GROUP	MODEL
Safety Recall Campaign	2011-2013MY Optima Hybrid (TF HEV)
NUMBER	DATE
SC284TE	May 2024

SAFETY RECALL CAMPAIGN

HECU MULTI FUSE REPLACEMENT (SC284TE)

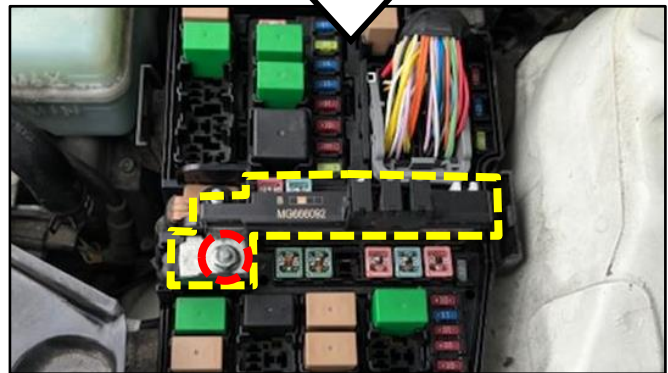
- 4a. Locate the Multi Fuse (A) for ABS1 and loosen the 10mm Multi Fuse retaining nut (B) and remove the Multi Fuse.

- 4b. Install the new Multi Fuse (A) and tighten the retaining nut (B).

Tightening torque for retaining nut (B):
7.2 - 8.7 lb.ft (9.8 - 11.8 N.m)

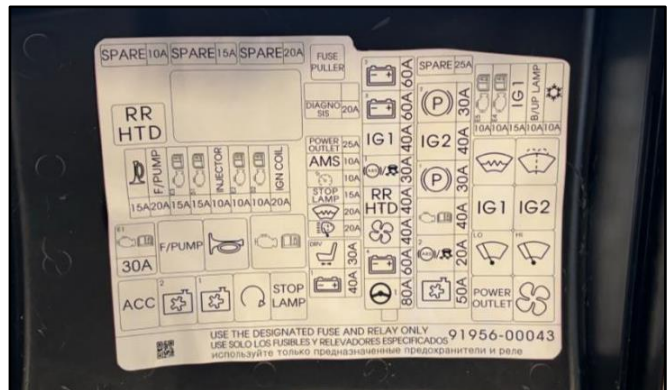
Note: Drill a hole through the center of the removed Multi Fuse. DO NOT reuse.

5. Adhere the new fuse label to the bottom of the new junction box fuse cover, as shown.
